EV Commission Progress:

The Grove at Shoal Creek Tree Survey & Disposition Plan
May 10, 2016

Tier 1 and Tier 2 Compliance Summary

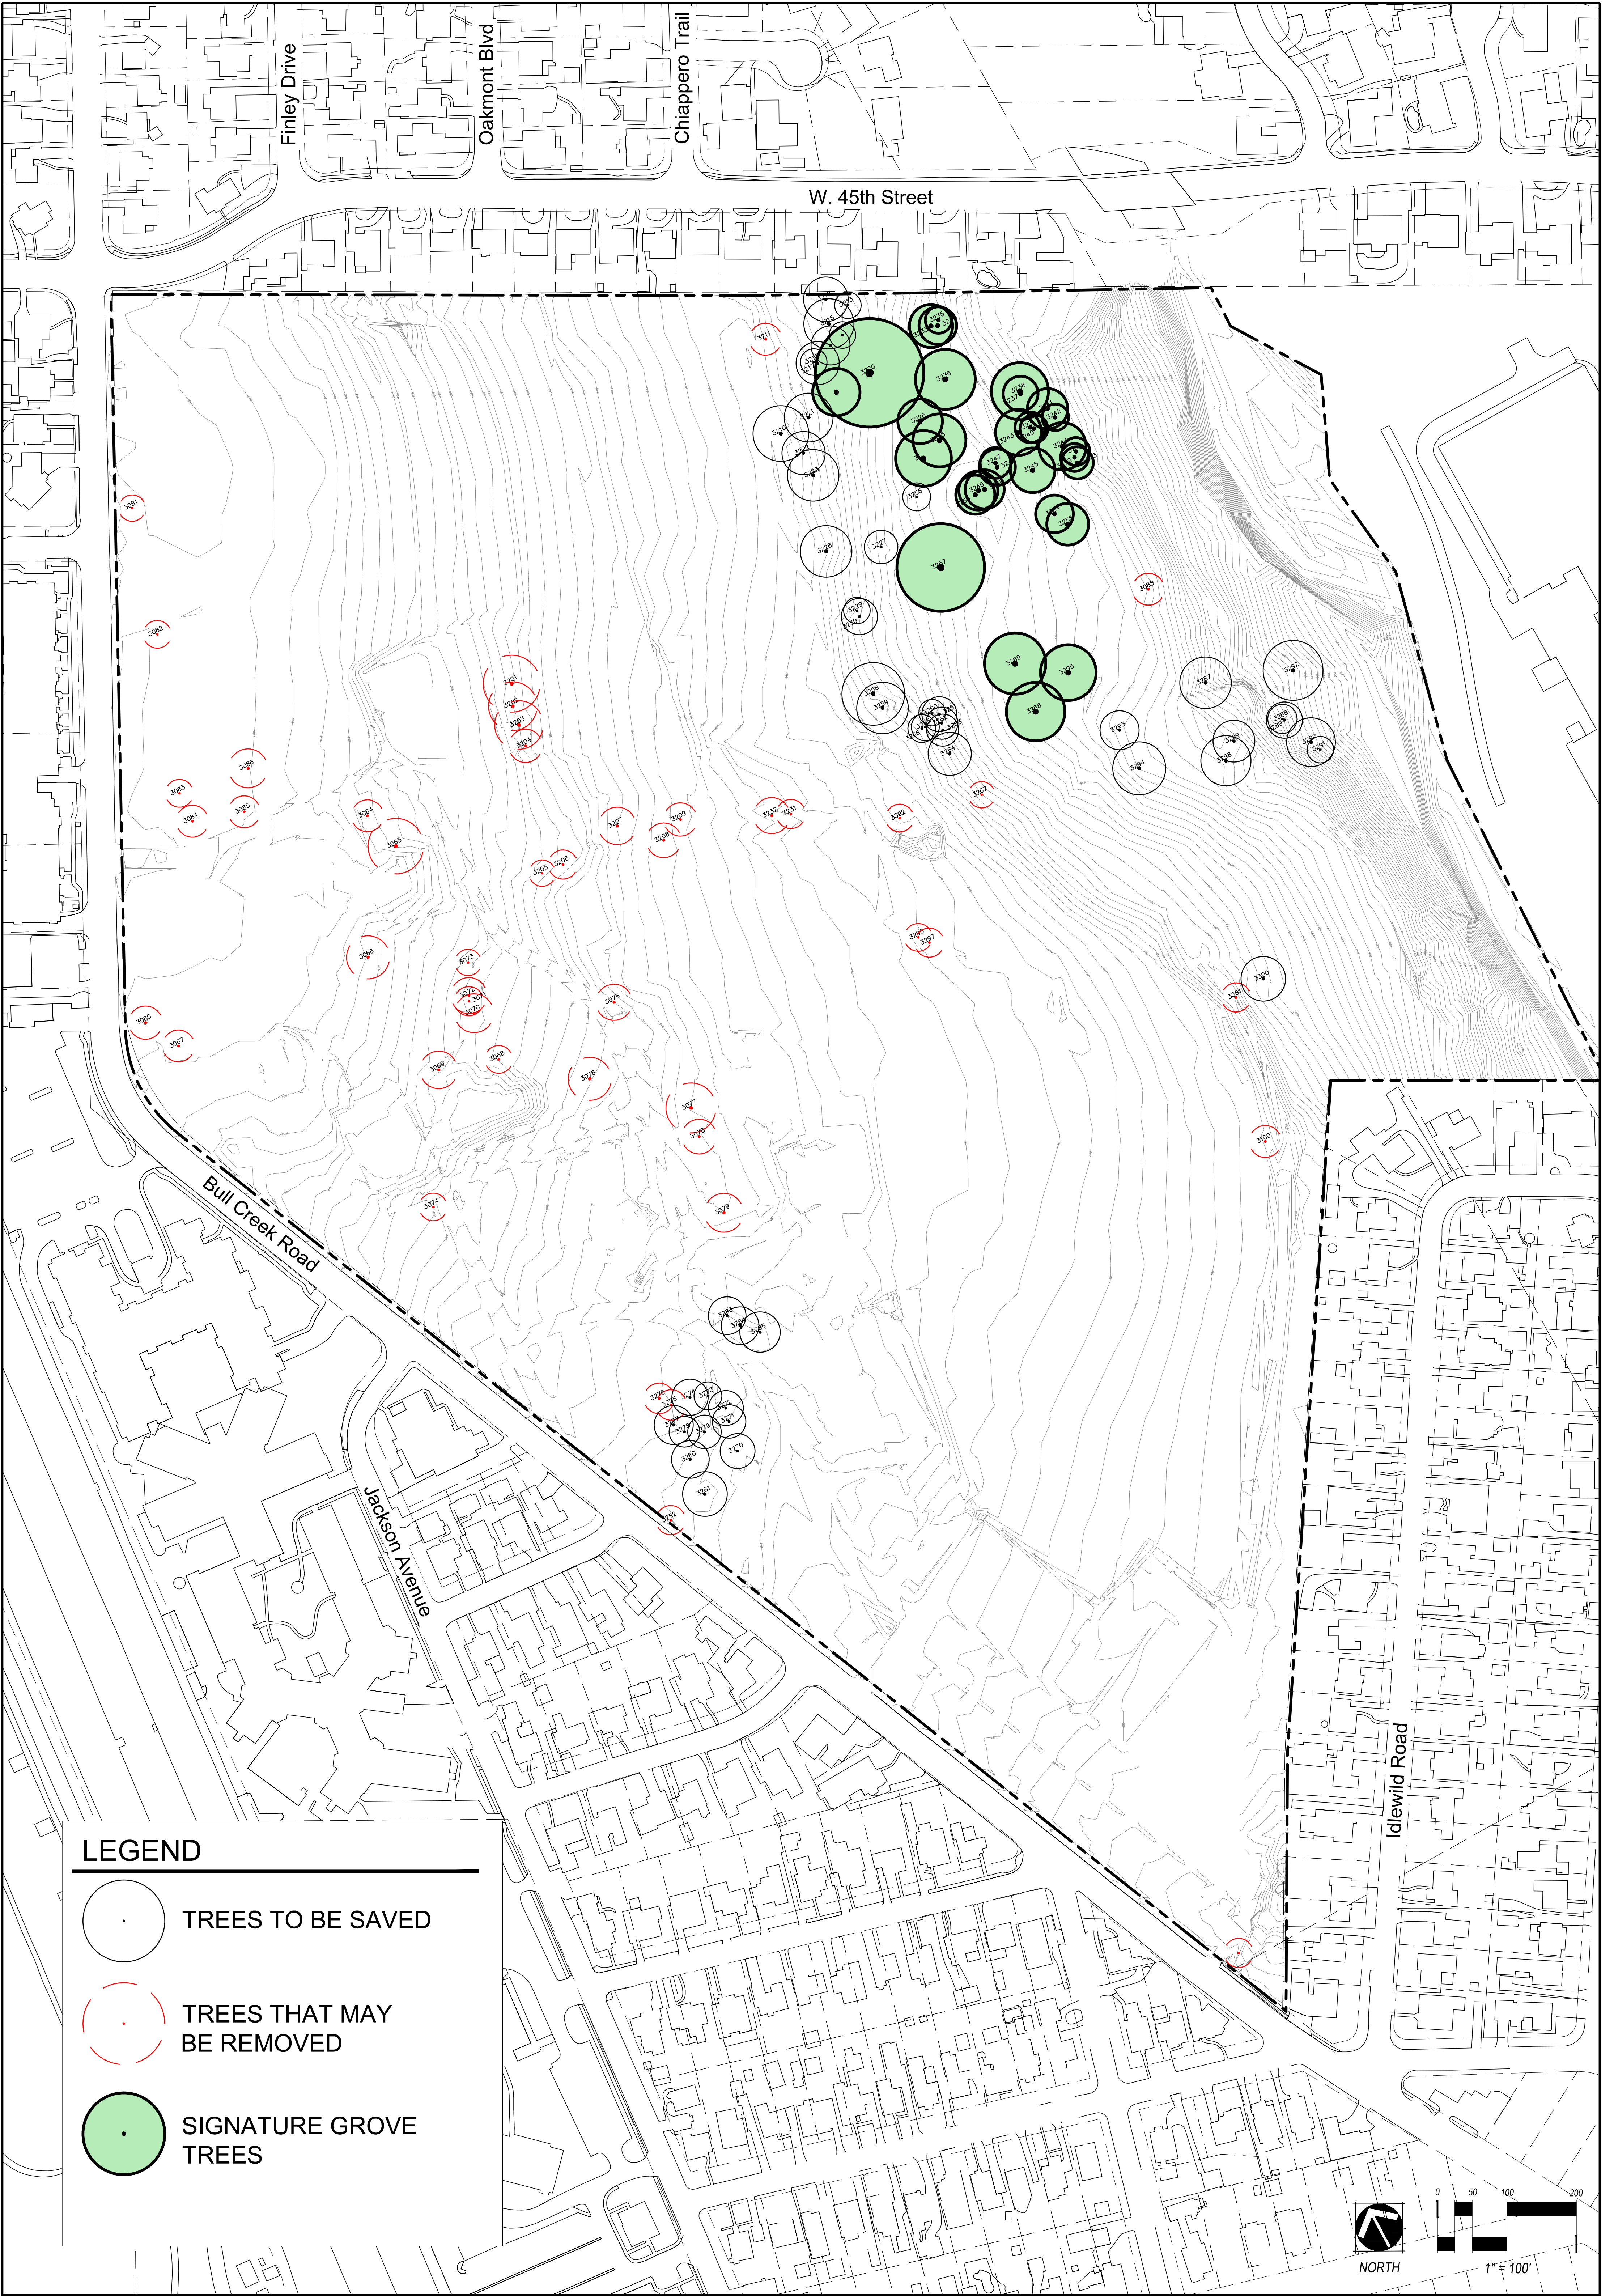
7. Protect 100% of the critical root zone of all trees.

Austin's Heritage Tree Foundation applies a very high standard for the protection of trees and spoke in favor of the proposed Tree Plan at the prior commission meeting. The conditions for their support, which the applicant has agreed to, include:

- a. Prioritizing air spading, root pruning, and other best practices for the required tree care plans.
- b. Requiring that any cuts within the ¾ CRZ be made with air spades in the Signature Grove.
- c. Preventing utilities from the full CRZ of the Signature Grove.
- d. Requiring decks or root spanning constructions in high use areas around trees.

These conditions will be included in the final zoning document. Updated Tree Disposition Plan, Code Modification Table, and Tier Compliance Table are attached here with proposed revisions to meet these conditions.

- Arborist rating 2 = poor. Trees # 3080, 3202, 3207 & 3232 were rated poor by the applicant's arborist and reviewed in the field by City Arborist Michael Embesi.

- Applicant is committing to save a minimum of 75% of Appendix F (Native) Protected size trees as shown in this table. Trees shown as saved may be removed if a similar size, similar condition tree noted for removal is substituted at Site Plan review.

- A mitigation rate of 100% shall be required for trees #3080, 3202, 3207 & 3232 (note that mitigation is typically not required for trees in this condition, but a 100% mitigation rate is offered as an element of superiority) . A mitigation rate of 300% shall be required for any other Heritage Trees that are removed. All other trees shall be mitigated per the Environmental Criteria Manual.

- The applicant shall provide a tree care plan for all preserved protected and heritage trees on site. The applicant shall allot a minimum of \$100 toward this plan for each inch of heritage trees removed from the site. This shall be above and beyond any mitigation required for these trees. The tree care plan shall prioritize remediation of construction impacts through air spading, root pruning, deep root fertilizing, and/or other practices as recommended by a certified arborist. Basic watering, mulching, and fencing during construction are assumed to be provided as best practices and would not count toward fulfillment of the tree care plan.

- For protected and heritage trees identified on the plan as "Signature Grove Trees", cut in the ¾ Critical Root Zone (CRZ) shall not exceed 4". This requirement may be administratively reduced to the ½ CRZ if a minimum of 75% of the total area of the full CRZ is preserved and a tree care plan in the amount of \$100 per caliper inch is provided for the tree in question.

- Any cuts within the ¾ CRZ of these trees shall made with an airspade or air knife and hand pruning prior to machine excavation.
 - Stormwater pipes to and from the water quality pond shall not be permitted to impact the full CRZ of Heritage Trees in the Signature Grove.

- Where high intensity, hardscape uses are planned around heritage trees located in the signature grove, the use areas should be constructed with decks, sand bridging, or other root bridging constructions to avoid heavy disturbance or compaction of the 1/2 CRZ of these trees.
